**89, 97 and 99 Church Street – Zoning Amendment
Request for Direction Report**

Date:	August 30, 2017
To:	Toronto and East York Community Council
From:	Director, Community Planning, Toronto and East York District
Wards:	Ward 28 – Toronto Centre-Rosedale
Reference Number:	16-142844 STE 28 OZ

Attachment 2: Site Plan

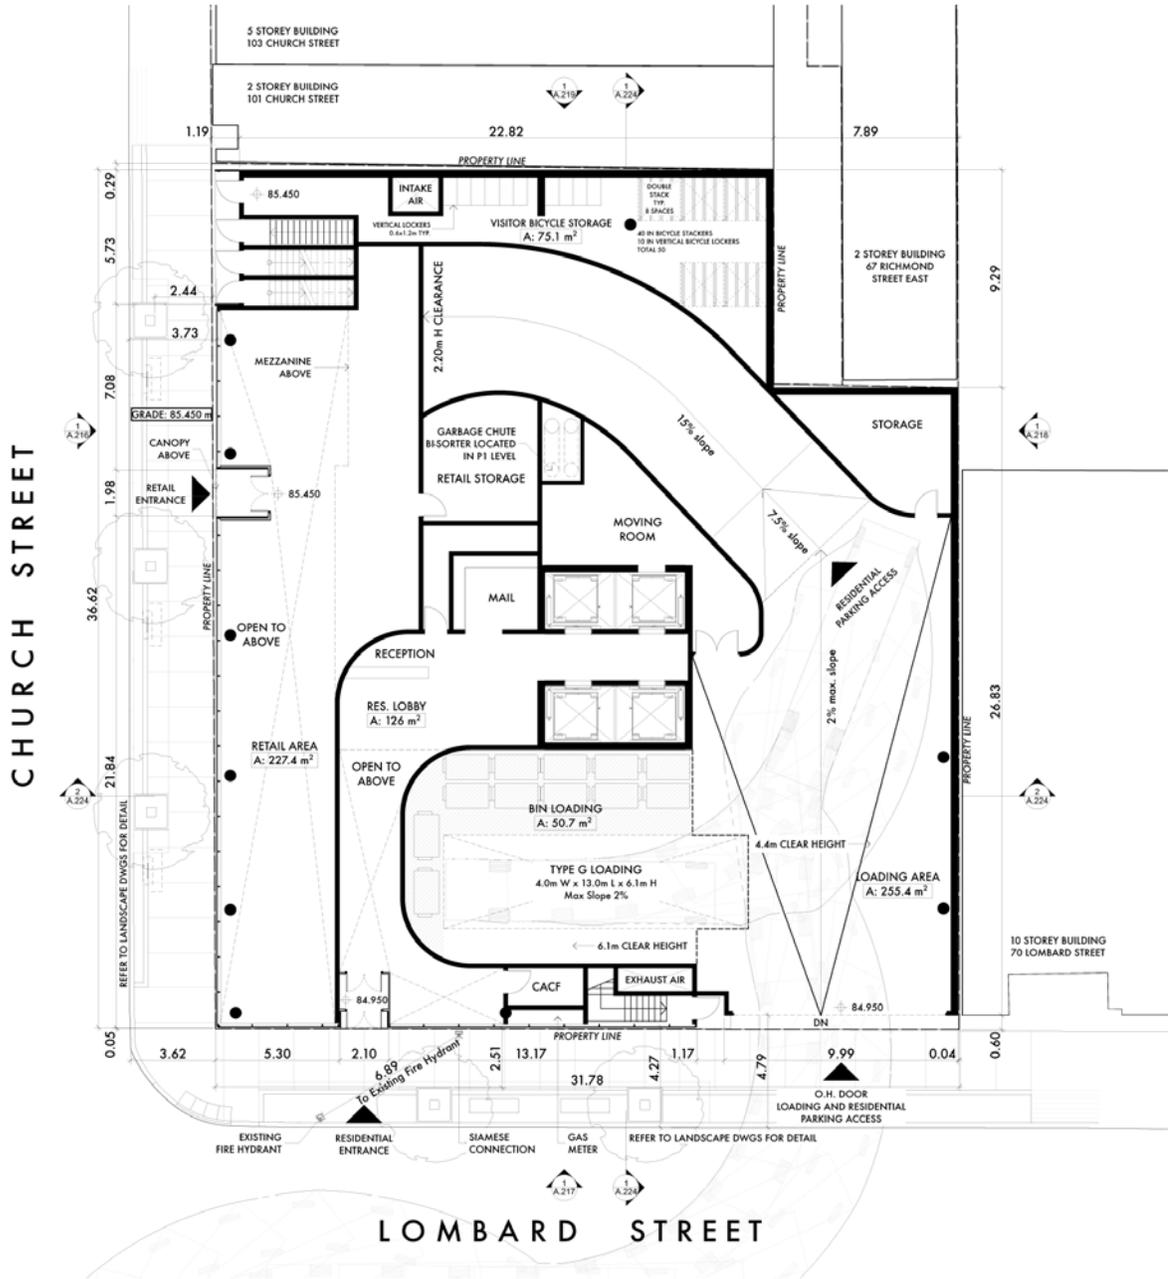
- g) The owner has submitted revised drawings that relocate and show that the structural column located at the south-west corner of the building will not encumber the surface easement described in 3 (f).

- The separation distance of the tower from the north lot line at 2.0 metres is well below the minimum recommended facing distance of 12.5 metres as per the City's Tall Building Guidelines and Council adopted Zoning By-law 1105-2016 (under appeal). Also it does not conform to Official Plan Amendment (OPA) 352 – Downtown Tall Building Setback Area (currently under appeal). While Planning staff have assessed that the adjacent northern property cannot accommodate a tall building, the existing buildings are heritage buildings and require an appropriate setback. As well, the as-of-right permitted height for the adjacent property is 30 metres. Planning staff are of the opinion that the tower setback should be a minimum of 5.5 metres from the northern lot line.
